WELL API NO. 30-025-27467
5. Indicate Type of Lease STATE ☒ FEE
6. State Oil & Gas Lease No. L-990
7. Lease Name or Unit Agreement Name West Knowles
8. Well Number #9
9. OGRID Number 113315
10. Pool name or Wildcat Knowles, West (Drinkard)

SUNDRY NOTICES AND REPORTS ON WELLS
(DO NOT USE THIS FORM FOR PROPOSALS TO DRILL OR TO DEEPEN OR PLUG BACK TO A DIFFERENT RESERVOIR. USE "APPLICATION FOR PERMIT" (FORM C-101) FOR SUCH PROPOSALS.)

Texland Petroleum-Hobbs is re-submitting the previously approved P&A (copy attached) for an extension approval.

OTHER: Revising an approved PA dated 1/19/21

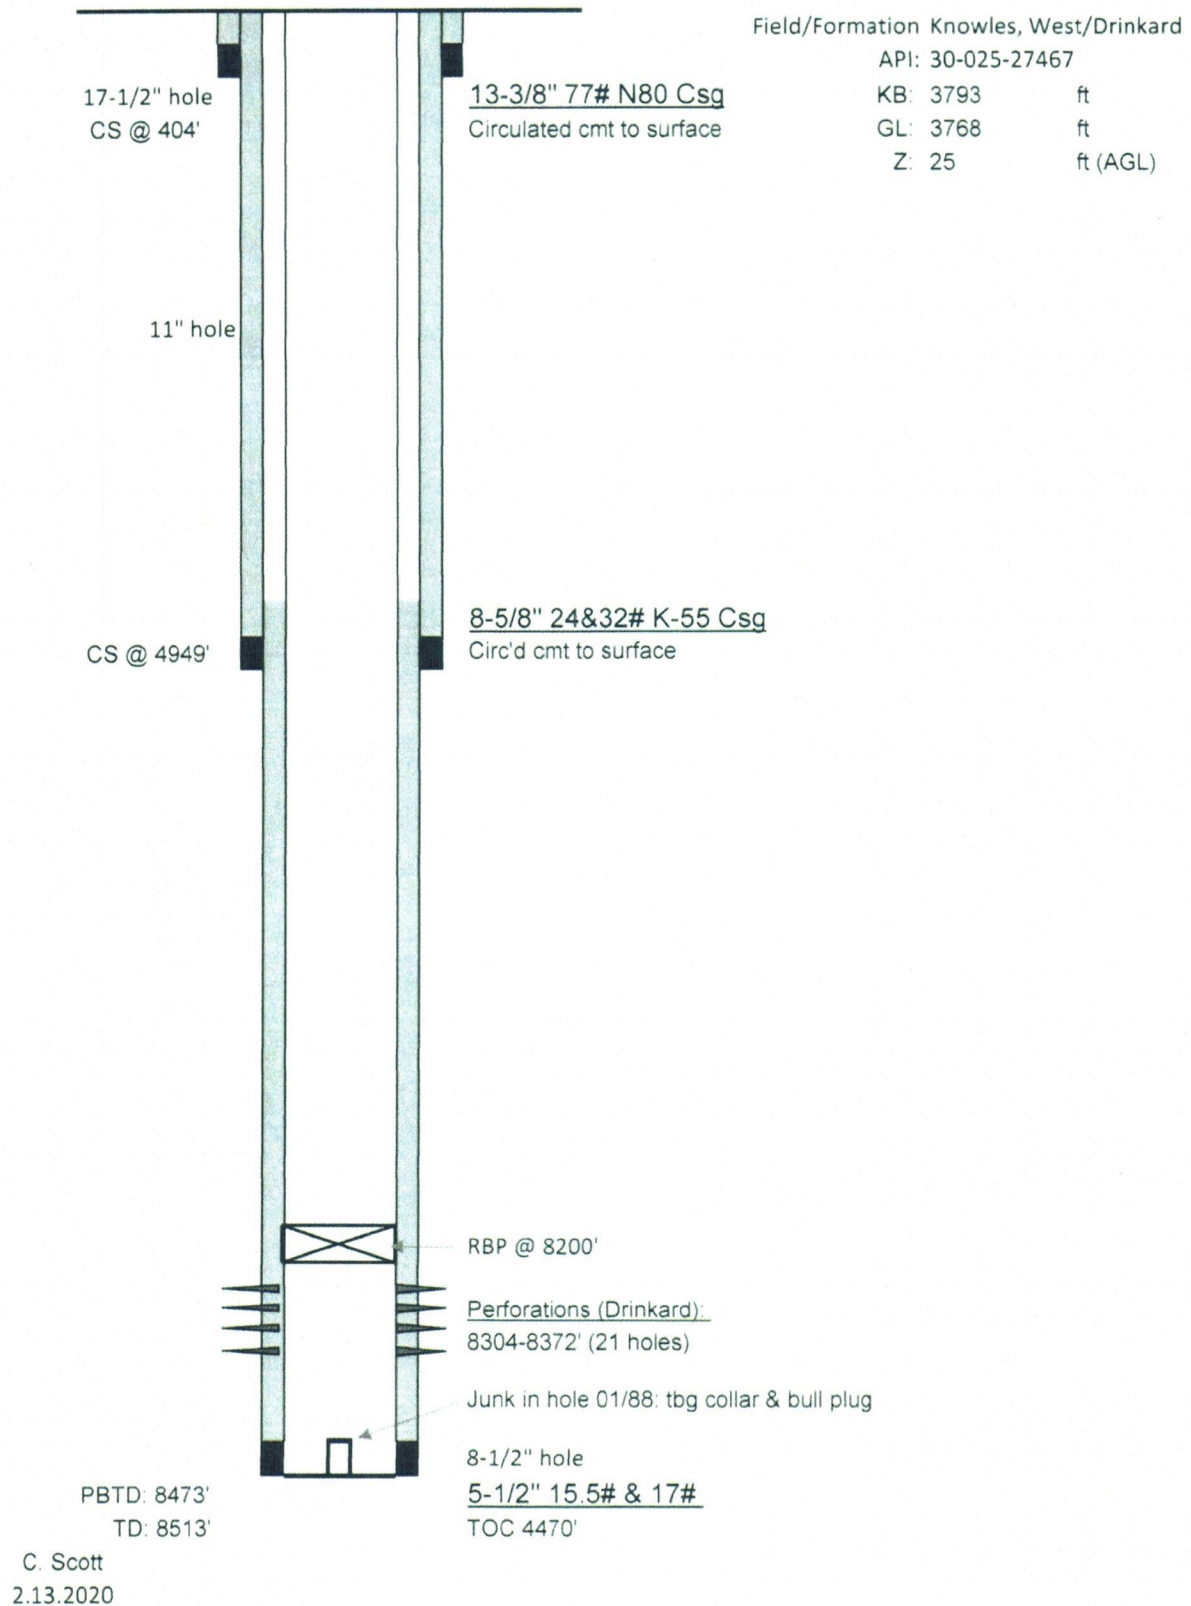
- 1) Set CIBP @ 8200' w/ ~~25~~ **30** sks cmt **30 sk Class H (Drinkard and Tubbs)**
- 2) Circ 9.5# salt gel mud between plugs
- 3) Spot 25 sk plug @ ~~5900-6100~~ **6250-6500** top Paddock
- 4) Spot 25 sk plug @ 4895-5000', WOC & Tag plug **P&S 50 sxs 3485 top of salt**
- P&S 50 sxs** 5) Spot 25 sk plug @ 2900-3150', WOC & Tag plug
- P&S 50 sxs** 6) Spot 25 sk plug @ 1900-2100', WOC & Tag plug
- P&S 100 sxs** 7) Spot 10 sk plug @ 460' to surface, circ to surface, install dry hole marker
